**Transport – The A449**

**Figure 1: The image shows the Applicant's route analysis from its current Transport Assessment. The geographically more direct and shorter routes offered by the A449-WMI link Road-A5 compared to that offered by the proposed scheme is absent from the Applicant's analysis.**

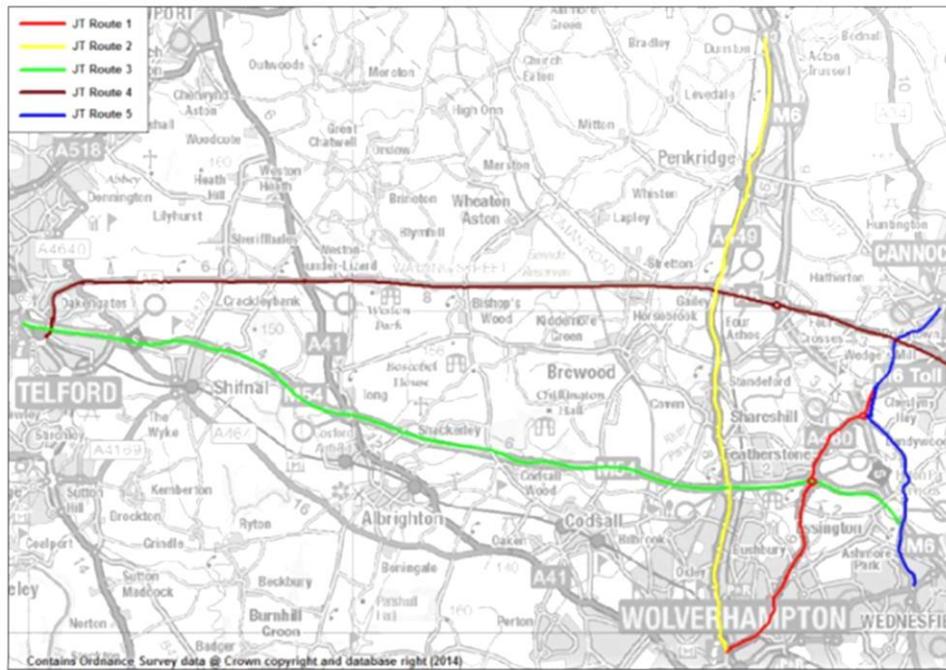
The Applicant has not provided journey time data that explains how long a journey would take using the A449-West Midlands Interchange (WMI) Link Road<sup>6</sup>-A5 route between M54-J2 and J12-M6 (and vice versa) compared to the time it would take to use the route that is offered by the proposed DCO. Figure 1 below shows the way in which the Applicant is trying to frame their analysis away from a direct scrutiny of the A449-WMI Link Road-A5 route.

**DW's Deadline 7 Question 5:** Could the Applicant please provide clear, unambiguous data so we can see the full extent of the journey time benefits offered by the proposed scheme? I would like to see the journey times from J2-M54 to J12-M6 in a simple two column table so that the two routes can be compared and contrasted.

**DW's Deadline 9 Response** – The Applicant has not answered my question. The A449 route through Penkridge is an irrelevant distraction. The inclusion of the M6 from J12 to J13 has the effect of slowing the overall A449-A5 route to a far greater extent than a simple J12 to J2 (M54) comparison. If the Applicant has nothing to hide, I see absolutely no reason why it could not oblige my request. I have produced my own table which I will send directly to the Applicant for clarification now that the open examination has closed (please see below).

*"Journey times for trips between M54 West (at J2) and M6 North (at J13) were compared in the Applicant's response document [REP4-033/8.19] to Daniel William's Question 11. While the representor has requested that M6 Junction 12 is used, the Applicant has provided data for trips to M6 Junction 13 to allow the comparison with the route through Penkridge. The time savings between these two points will be the same as the requested M6 Junction 12 as it would take the same time to travel along the M6 between J12 and J13 for either options using this route. The information provided previously, has been converted to a table form below to aid understanding as requested by the representor. As noted previously, using the M54 to M6 Link Road Scheme between M54 J2 and M6 J12 will be quicker (by more than 2 mins) than using the A449 and A5 in both the northbound and the southbound directions."*
